UNITED STATES PATENT AND TRADEMARK OFFICE

10/624,542

Office Action Summary

DETAILED ACTION

Fig. 1

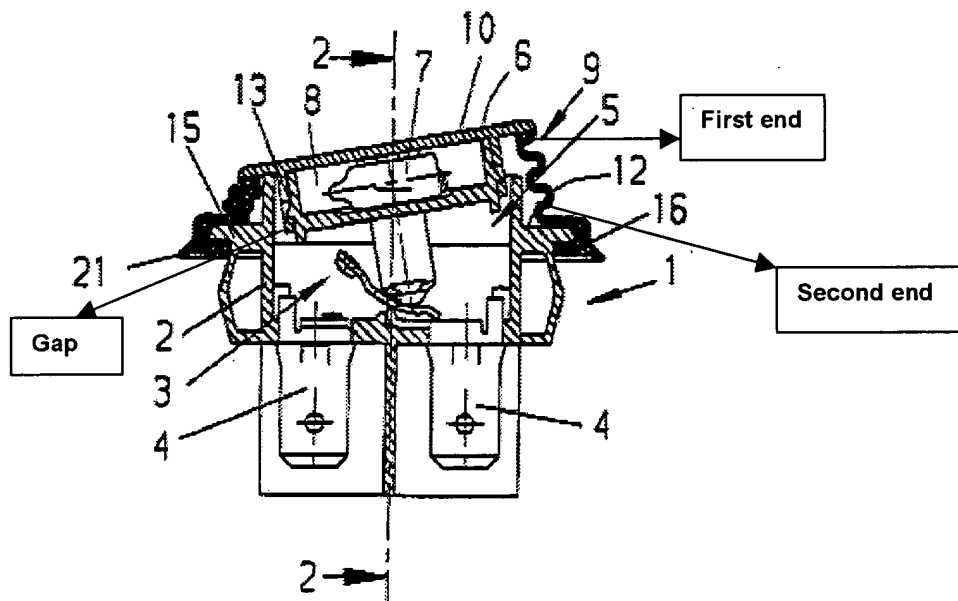
Rapp discloses an electrical switch comprising:

- a housing 2 having an opening 5;
- a plurality of fixed contacts 4 located in the housing for movement;
- at least one moving contact 3 movable by the switching member (see the attachment) for movement to come into contact with and out of contact from the fixed contacts, and

- an actuator 9 disposed in the opening 5 for movement to actuate the switching member (see the attachment) and in turn the moving contact, with a gap (see the attachment) formed between the actuator 9 and the opening 5 that surrounds the actuator 9;

- wherein a resiliently deformable seal 11 and 12 is connected across the opening 5 and the actuator 9 to seal off the gap (see the attachment), thereby avoiding entrance of foreign matter through the gap (see the attachment) into the housing 2;

- wherein the seal 11 and 12 has a folded cross-section providing the extended length;

- the seal across section has a U-shaped bend pointing inwards;

- the seal has an intermediate portion (see the attachment) between the opening and the actuator, the portion being folded and having a reduced thickness;

- the seal 11 and 12 comprises a sleeve having opposite ends connected to the opening 5 and the actuator 9 respectively, a first of the ends (see the attachment), being disposed around the corresponding one of the opening and actuator 9;

- the second end (see the attachment), is also disposed around the other of the opening and actuator;

- the first end is stretched around a part forming the opening or of the actuator to which the first end is connected;

- the first end and a part forming the opening or of the actuator to which the first end is connected have complementary cross-sections mated together;

- the seal comprises an inner part (see the attachment), that is resiliently deformable and an outer part (see the attachment), that is considerably thicker than the inner part and surrounds and protects the actuator;
- the inner and outer parts together have a Z-folded cross-section.

Fig. 4

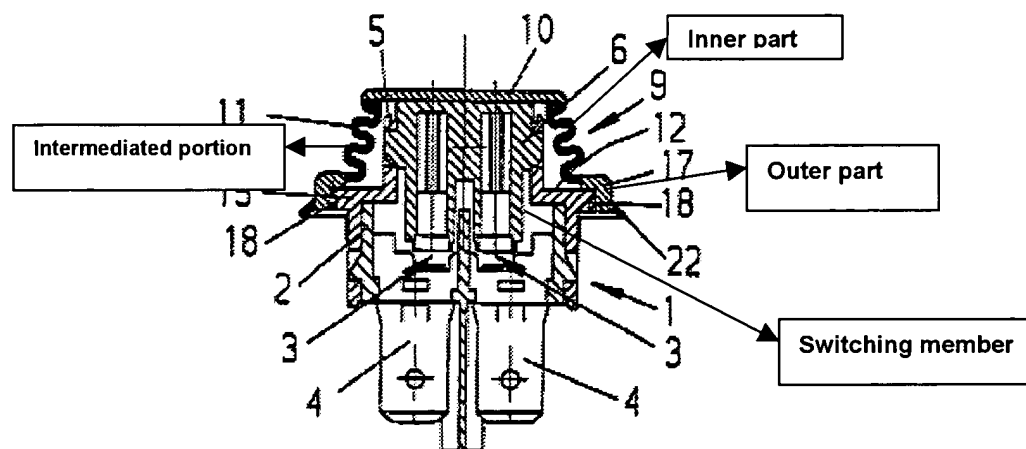
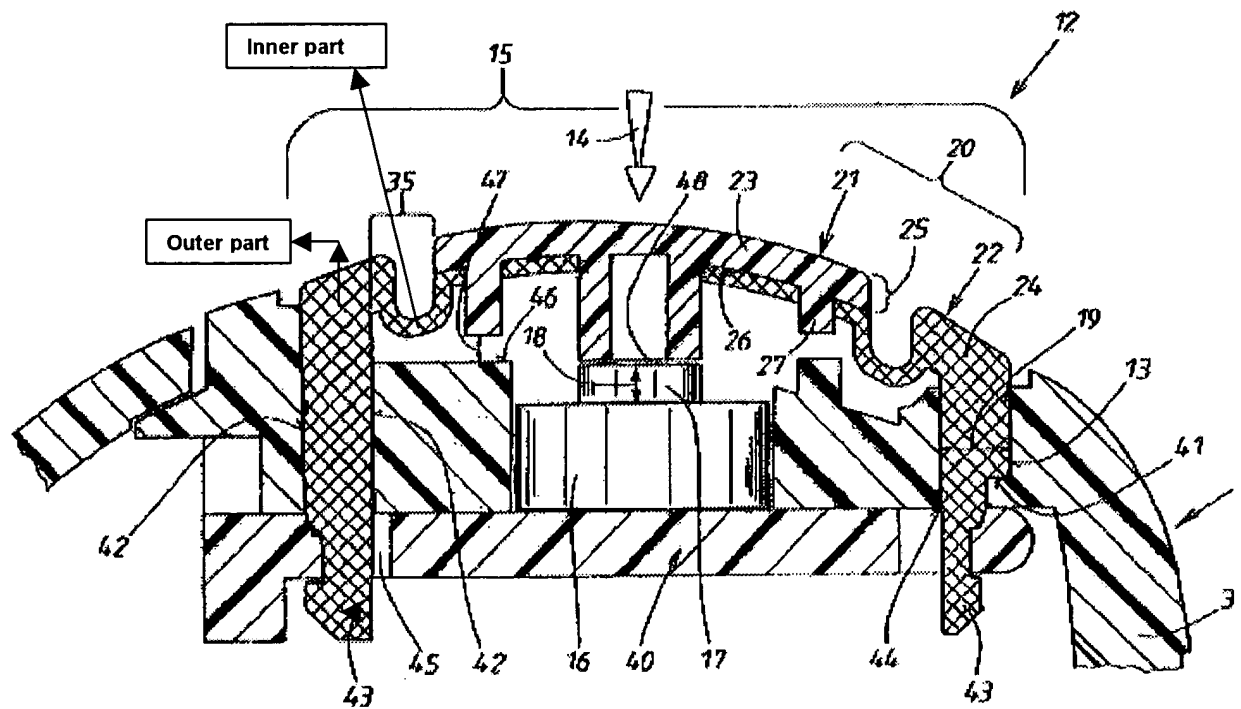
Klein discloses an outer door handle comprising a pushbutton switch 15;

- the outer part 24 is *substantially* cylindrical and contains *substantially* wholly the inner part (see the attachment).
